Rampion 2 Wind Farm

8.54 Applicant's Responses to Examining Authority's First Written Questions (ExQ1)

Application Reference: 8.54

Figure 2 Oakendene onshore substation:
Indicative SuDS plan and risk of flooding from surface water

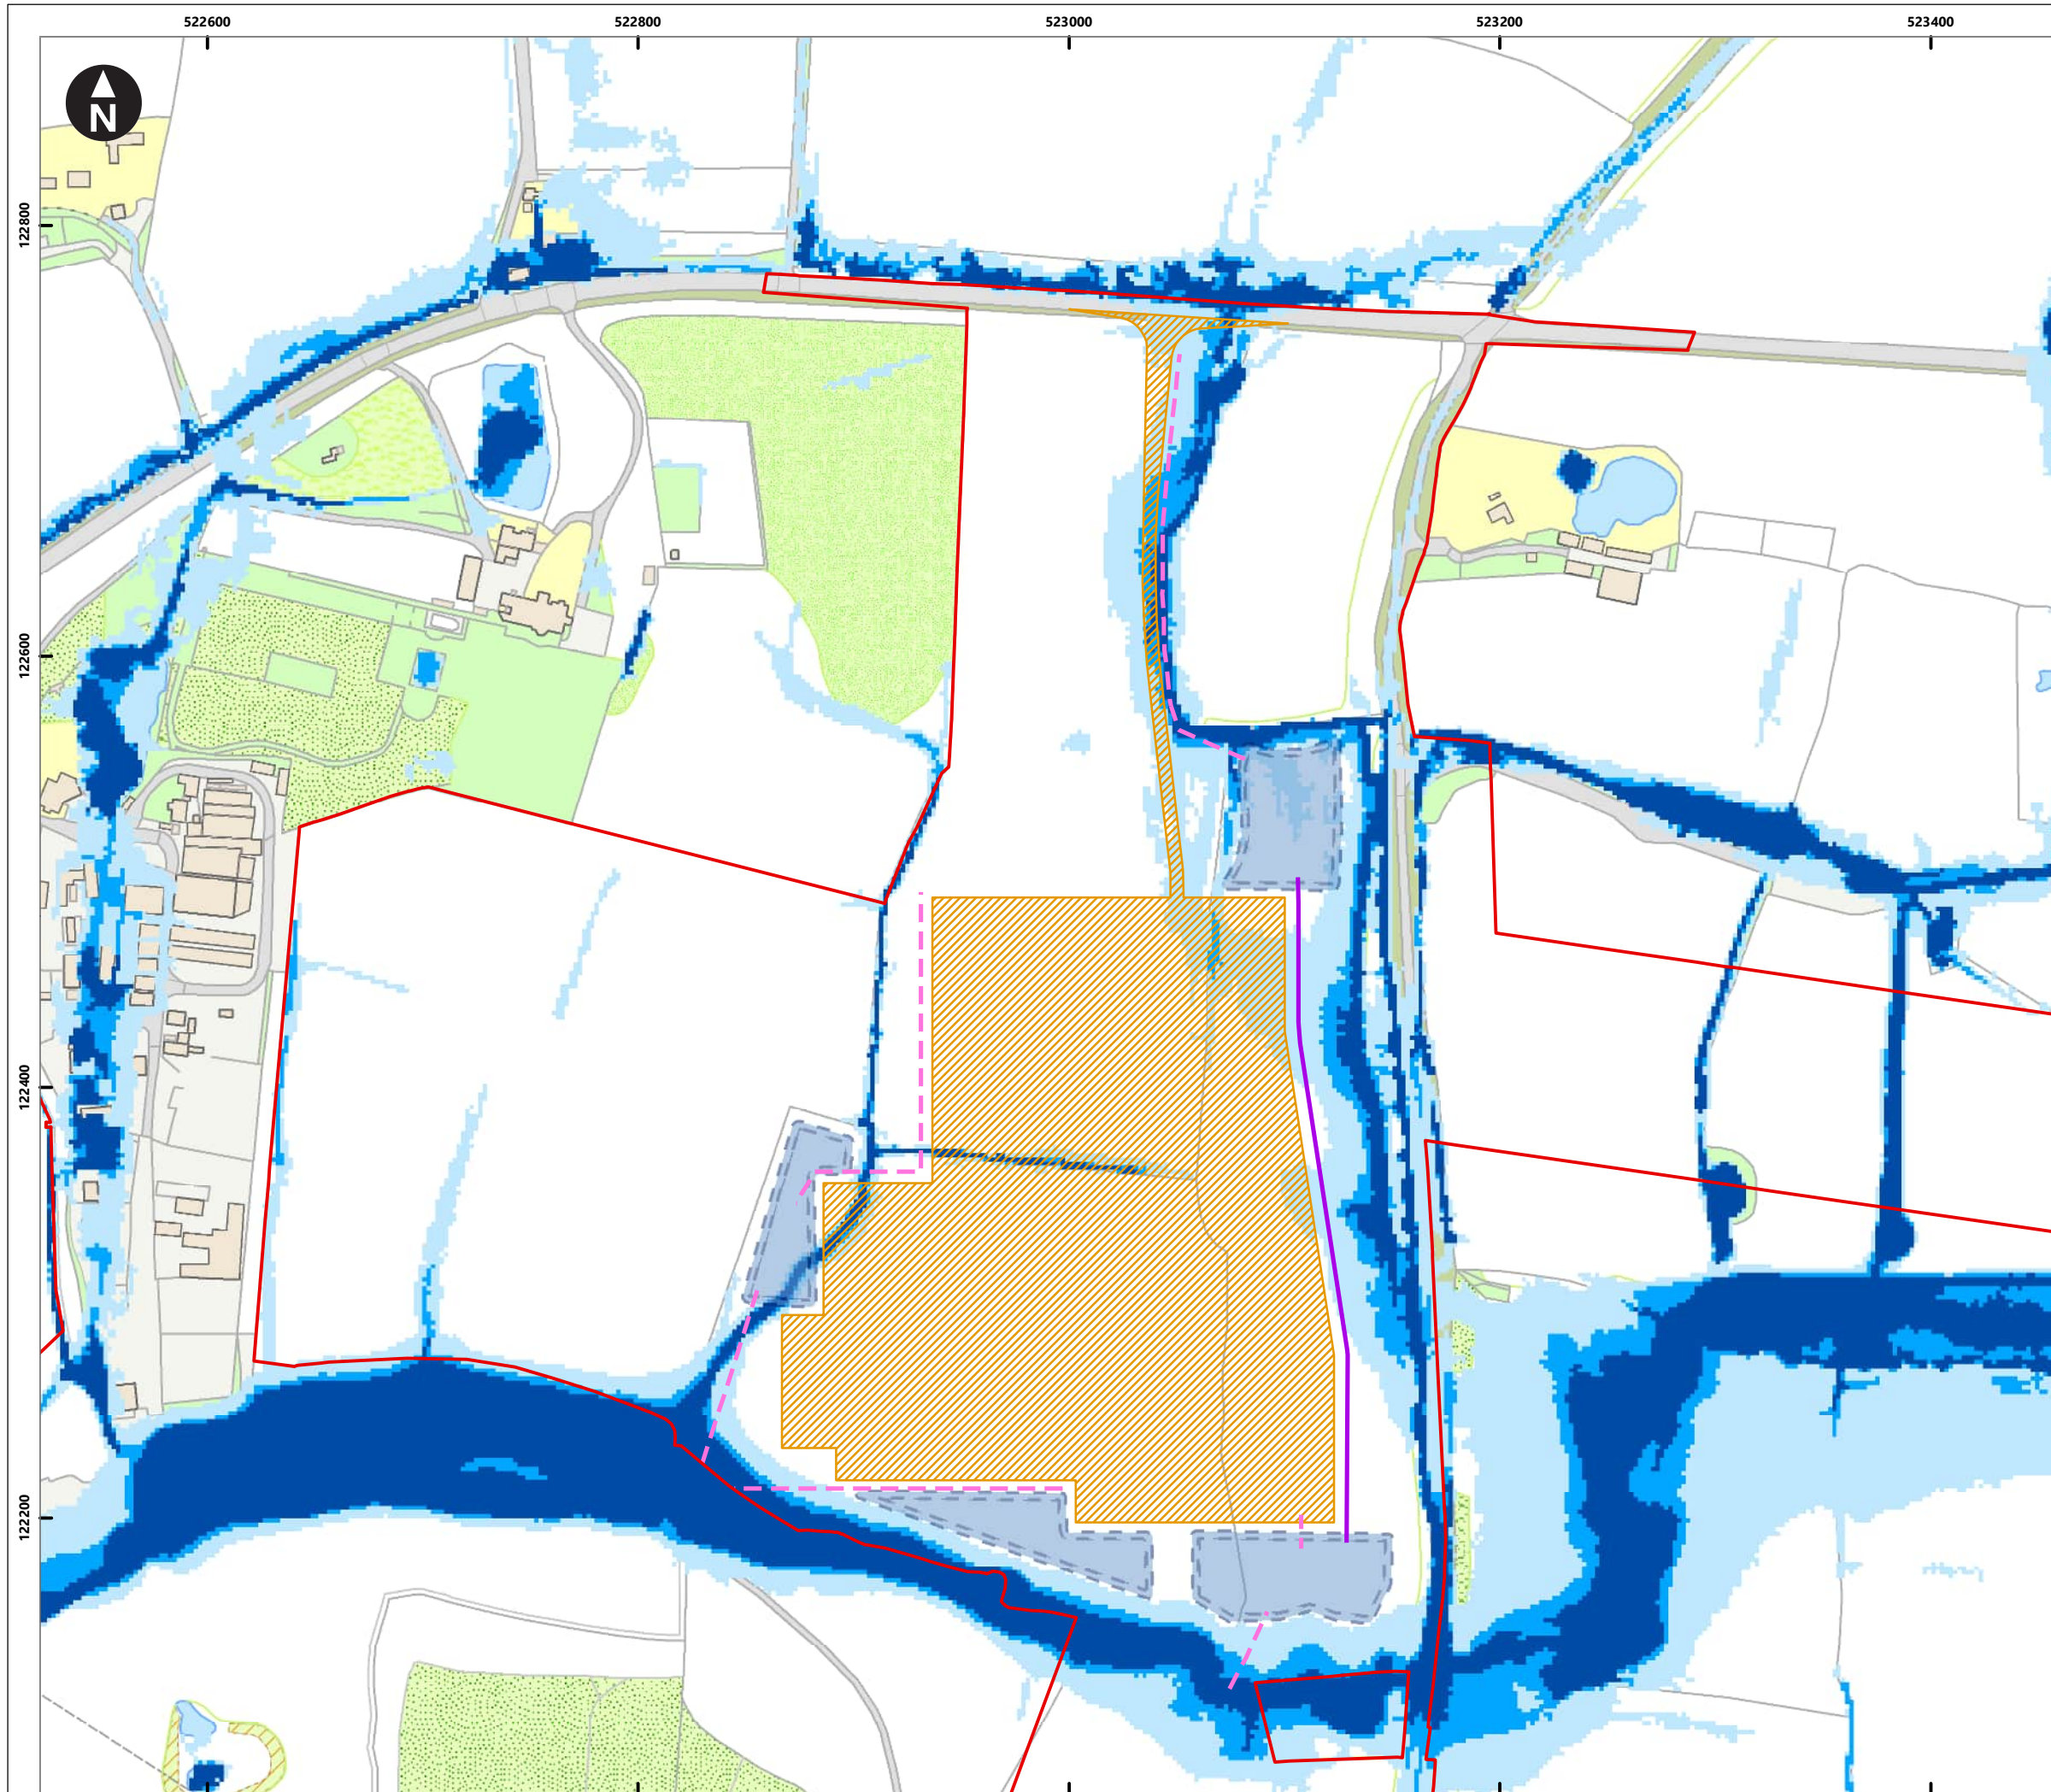
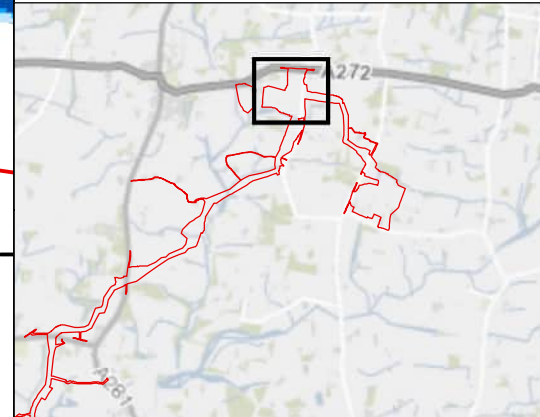
*“Flood Risk at the Proposed Substation site at Oakendene
The Flood Risk Assessment [APP-216] states that the proposed substation site at Oakendene is within Flood Zone 1 and this was confirmed by the Applicant during questioning at ISH1 [EV3-001] whilst Mr Smethurst believes the site falls within Flood Zone 3 [REP1-115]. Figure 26.2.2 in the Flood Risk Assessment [APP-216] shows which areas of the whole of the Proposed Development fall within various flood zones in Figure 26.2.2 but the ExA considers it difficult to see any detail at this scale for the proposed Oakendene substation site*

- 1.2.7 It is acknowledged that the attenuation basins are indicated on the edge of this flood extent (as shown in **Figure 2** in **Annex B**), and thus that flooding of the

- 2.2.9 The Environment Agency Risk of Flooding from Surface Water extents were presented in Figure 26.2.6a of **Appendix 26.2: Flood Risk Assessment, Volume 4** of the ES [APP-216] and **Figure 2** provided in **Annex B** of this Appendix reproduces this, but with the addition of the indicative SuDS features, to demonstrate that those features have been located outside of the flood extent (to assist in answering question **FR 1.2 part b** (above) and **FR 1.3 part b** (below)). In this instance, we suggest that the 3.33% AEP RoFSW extent can be used as a proxy for Flood Zone 3b (as the closest magnitude event to the 5% AEP definition), and the 1% AEP and 0.1% AEP extents can be used as proxies for Flood Zones 3 and 2, respectively (with the 0.1% AEP extent also providing a proxy for the 1% AEP plus climate change extent, as discussed previously).
